**Advisory Action
Before the Filing of an Appeal Brief**

10/790,923

FRYE, NANCY C.

FIG. 12

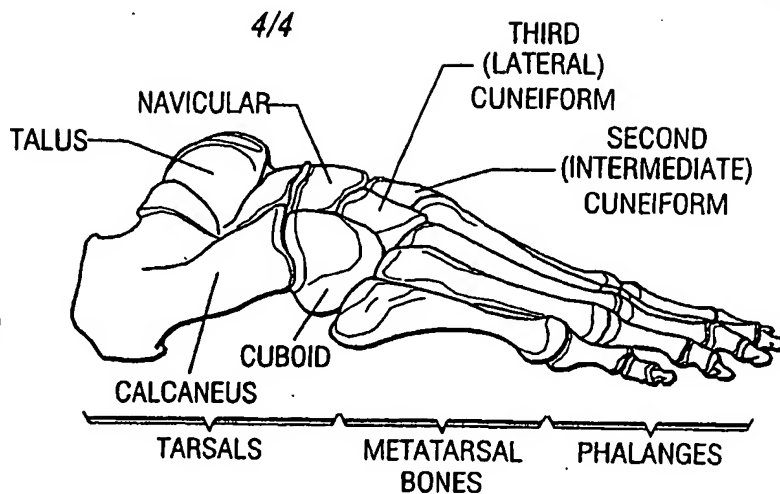
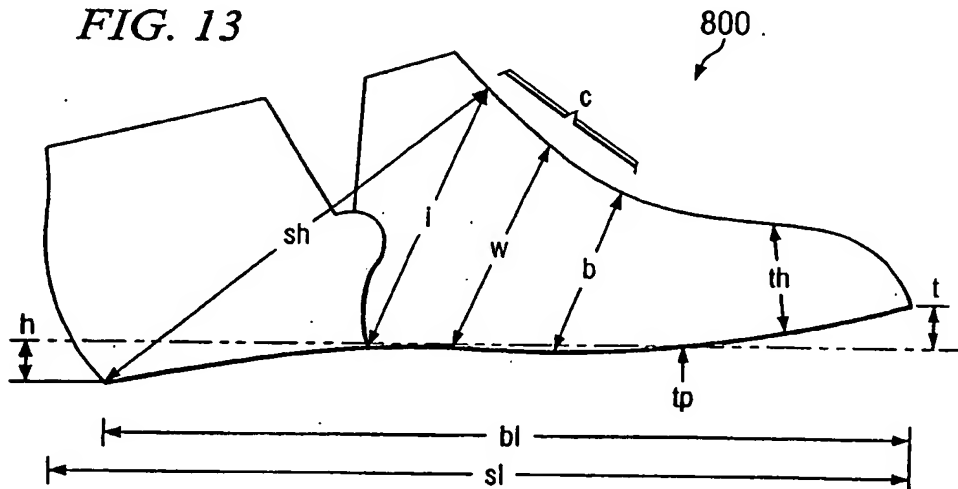
Continuation of 3. NOTE: The proposed amendment to the drawings raise new issues and new matter.

Continuation of 11. does NOT place the application in condition for allowance because: The proposed amendment to the drawings raises new matter issues as discussed in the Final Rejection. Claims 2 and 10 clearly and solely recite intended use functions and do not recite any structural limitations and therefore do not comply with 35 USC 112 second paragraph. In response to applicants' arguments directed towards Lodispoto, the top insole layer of Lodispoto (21) clearly has a rear heel section shown at line (c) which has a surface closer to the outsole than the surface at the forward toe section shown at line (a). In figure 5 the heel of the wearer is clearly shown as being carried closer to the walking surface than the forefoot. In reference to the term "planar", Lodispoto shows a planar outsole inasmuch as applicant has shown and defined such especially since the term planar is a description of a surface, the top surface of the outsole of Lodispoto appears to be planar and therefore the outsole is considered to be a "planar outsole". Applicants' arguments directed towards Snabb and Robinson were addressed in the Final rejection. In reference to applicants' arguments directed towards the double Patenting rejection, the Examiner has clearly recited the motivation and shown reference and explained the rejection in the final rejection. .

*Do Not enter
mkt 2/16/06*
